JOB NAME:
**TENANT IMPROVEMENTS FOR:
 JUAN BLANCO'S TACOS + TEQUILA**

LOCATION:
**1655 E. AUBURN ROAD
 ROCHESTER HILLS, MI 48307**

**ACCESSIBILITY
 &
 LIFE SAFETY PLAN**

FULL PLAN SET.pdf Markup Summary

A001

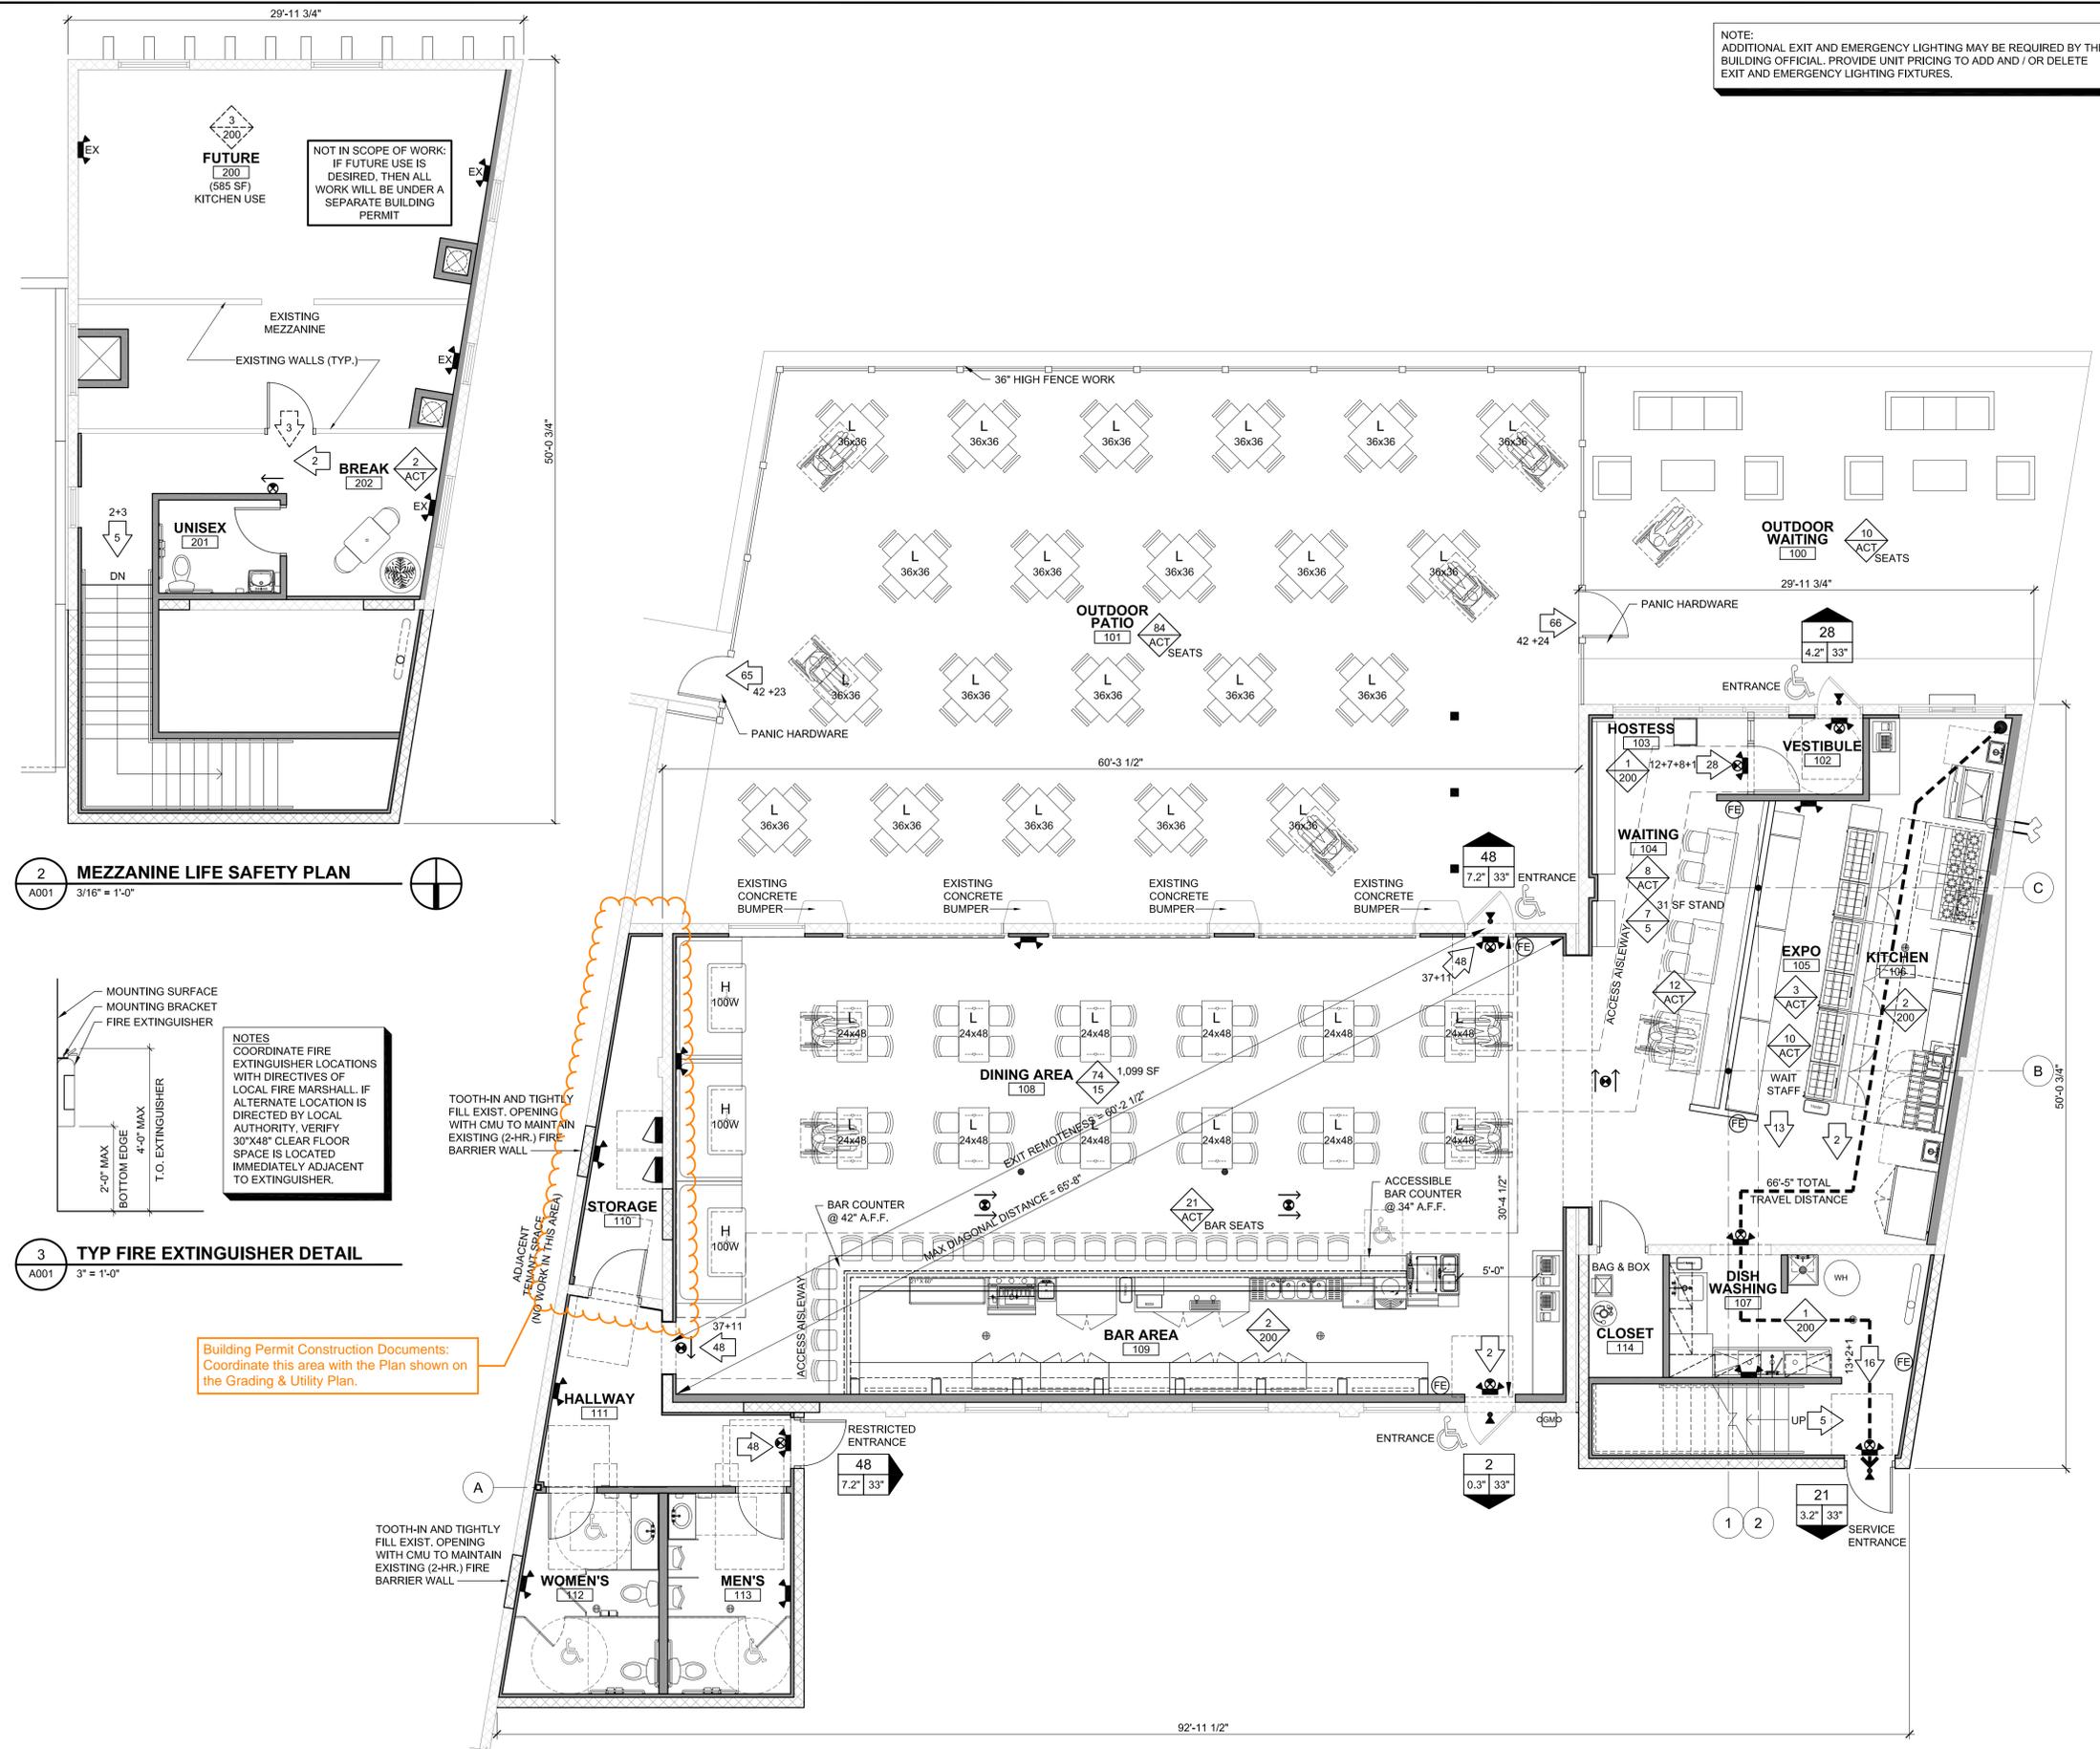
Building Permit Construction Documents:
This area appears to be part of the existing building footprint per Sheet A001.

A101

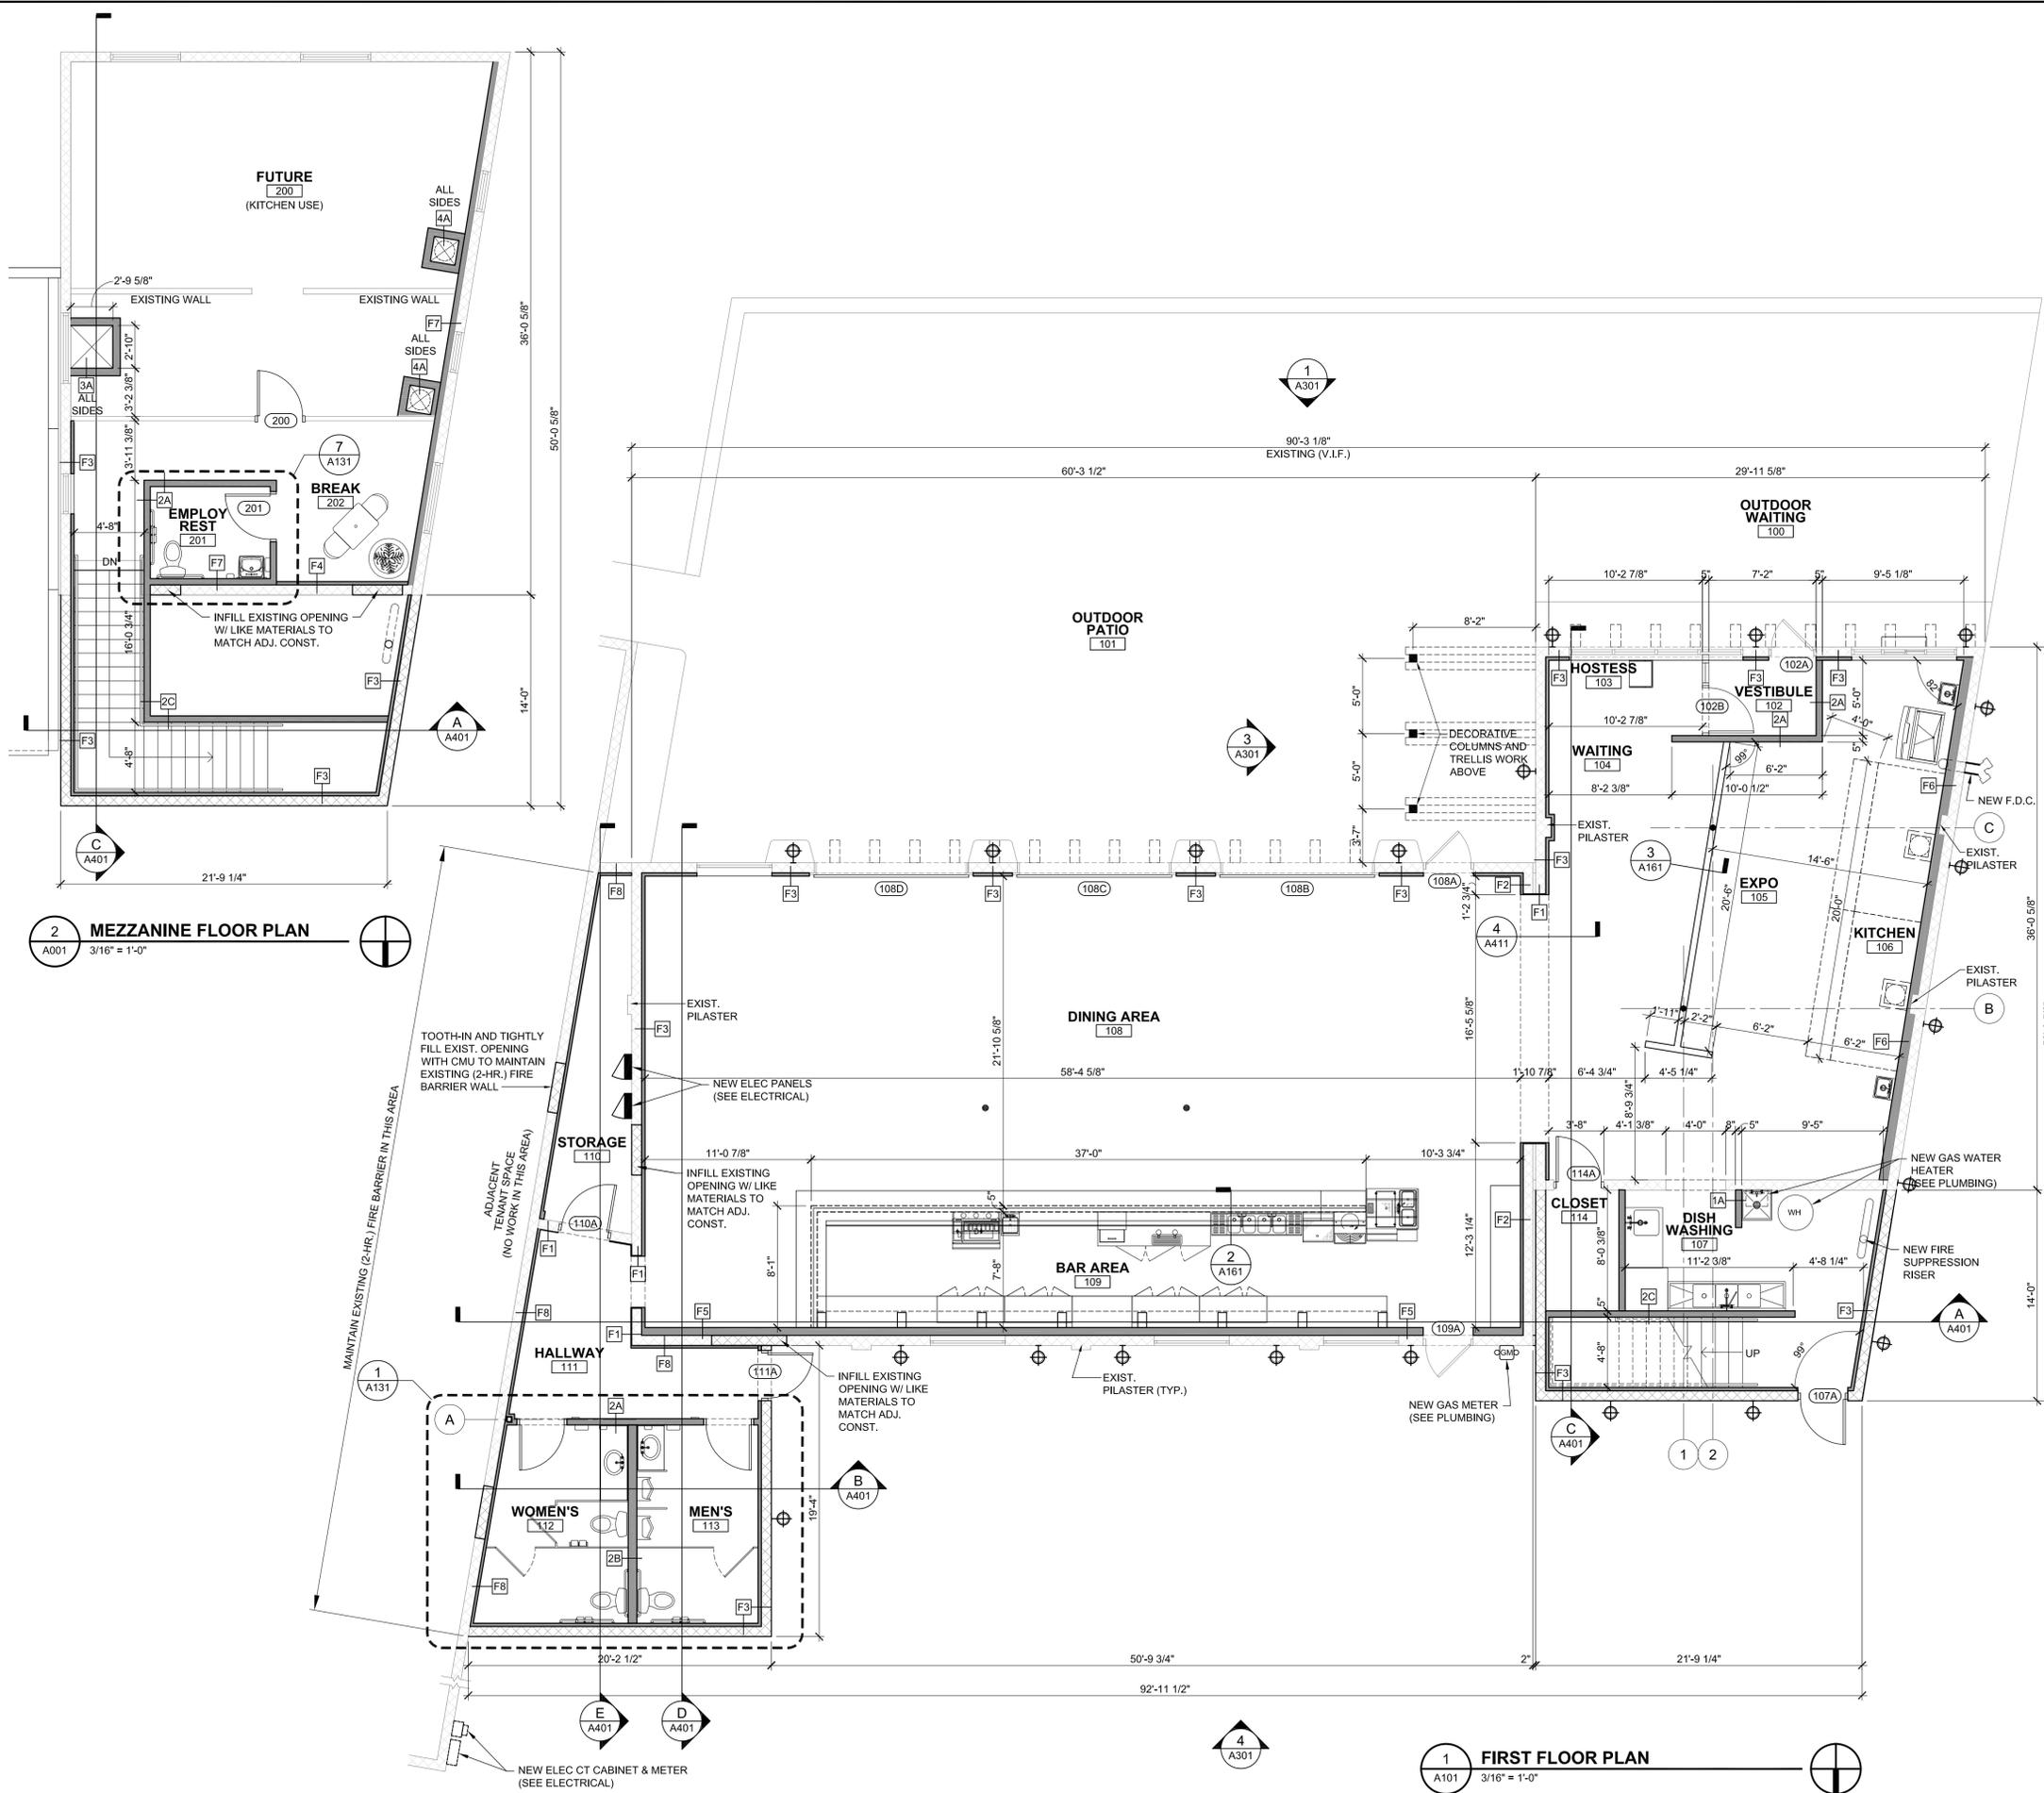
Building Permit Construction Documents:
Coordinate this area with the Plan shown on the Grading & Utility Plan.
